SAN ONOFRE NUCLEAR GENERATING STATION, UNIT 2

AMENDMENT TO FACILITY OPERATING LICENSE

Amendment No. 43
License No. NPF-10

ATTACHMENT TO LICENSE AMENDMENT NO. 43

Figure 3.1-1

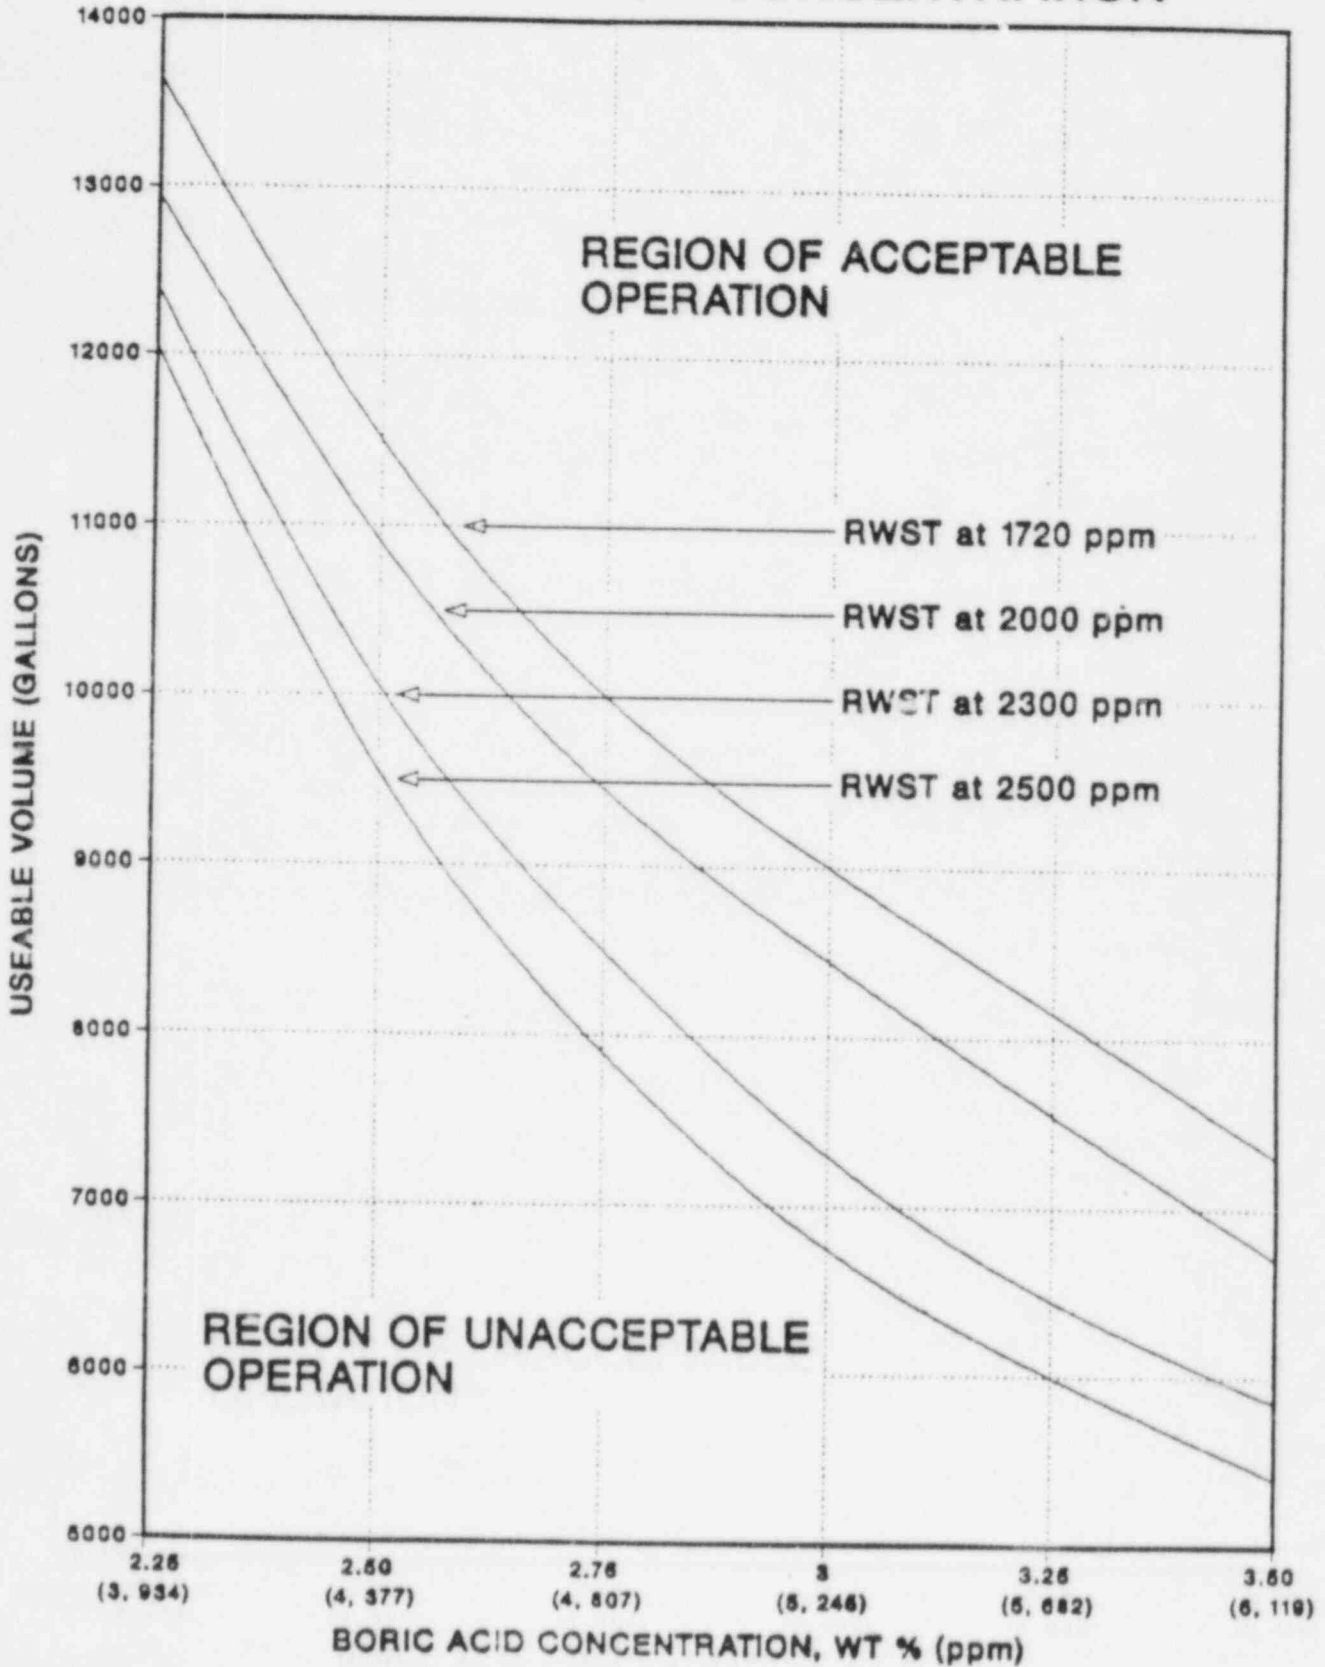
- a. At least one of the following combinations:
 - 1) One boric acid makeup tank, with the tank contents in accordance with Figure 3.1-1, its associated gravity feed valve, and boric acid makeup pump.
 - 2) Two boric acid makeup tanks, with the combined contents of the tanks in accordance with Figure 3.1-1, their associated gravity feed valves, and boric acid makeup pumps,
 - 3) Two boric acid makeup tanks, each with contents in accordance with Figure 3.1-1, at least one gravity feed valve, and at least one boric acid makeup pump, and
- b. The flow path from the refueling water storage tank.

- a. At least one of the following combinations:
 - 1) One boric acid makeup tank, with the tank contents in accordance with Figure 3.1-1, its associated gravity feed valve, and boric acid makeup pump,
 - 2) Two boric acid makeup tanks, with the combined contents of the tanks in accordance with Figure 3.1-1, their associated gravity feed valves, and boric acid makeup pumps,
 - 3) Two boric acid makeup tanks, each with contents in accordance with Figure 3.1-1, at least one gravity feed valve, and at least one boric acid makeup pump and,
- b. The refueling water storage tank with:
 1. A minimum contained borated water volume of 362,800 gallons above the ECCS suction connection,
 2. Between 1720 and 2500 ppm of boron, and
 3. A solution temperature between 40°F and 100°F.

Figure 3.1-1

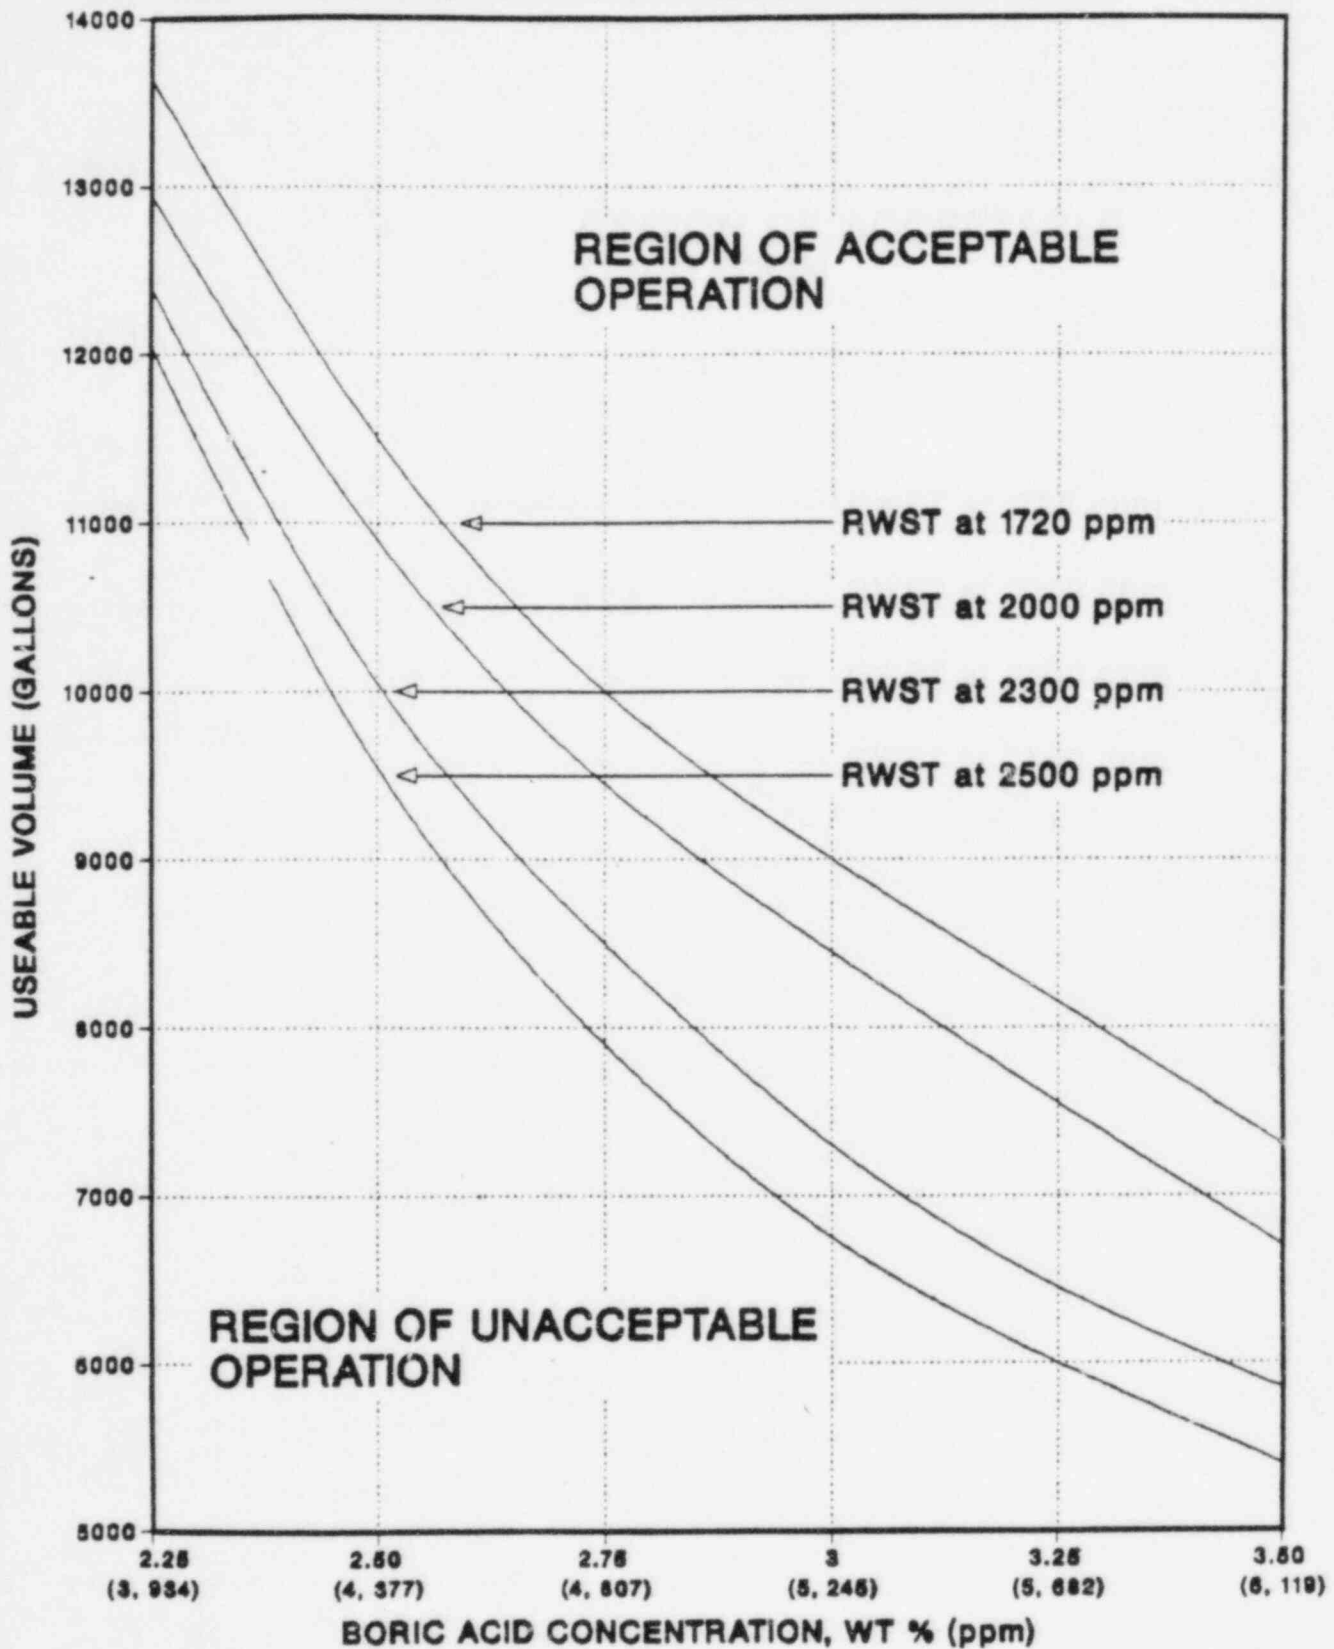
- a. At least one of the following combinations:
 - 1) One boric acid makeup tank, with the tank contents in accordance with Figure 3.1-1, its associated gravity feed valve, and boric acid makeup pump.
 - 2) Two boric acid makeup tanks, with the combined contents of the tanks in accordance with Figure 3.1-1, their associated gravity feed valves, and boric acid makeup pumps,
 - 3) Two boric acid makeup tanks, each with contents in accordance with Figure 3.1-1, at least one gravity feed valve, and at least one boric acid makeup pump, and
- b. The flow path from the refueling water storage tank.

- a. At least one of the following combinations:
 - 1) One boric acid makeup tank, with the tank contents in accordance with Figure 3.1-1, its associated gravity feed valve, and boric acid makeup pump,
 - 2) Two boric acid makeup tanks, with the combined contents of the tanks in accordance with Figure 3.1-1, their associated gravity feed valves, and boric acid makeup pumps,
 - 3) Two boric acid makeup tanks, each with contents in accordance with Figure 3.1-1, at least one gravity feed valve, and at least one boric acid makeup pump and,
- b. The refueling water storage tank with:
 1. A minimum contained borated water volume of 362,800 gallons above the ECCS suction connection,
 2. Between 1720 and 2500 ppm of boron, and
 3. A solution temperature between 40°F and 100°F.
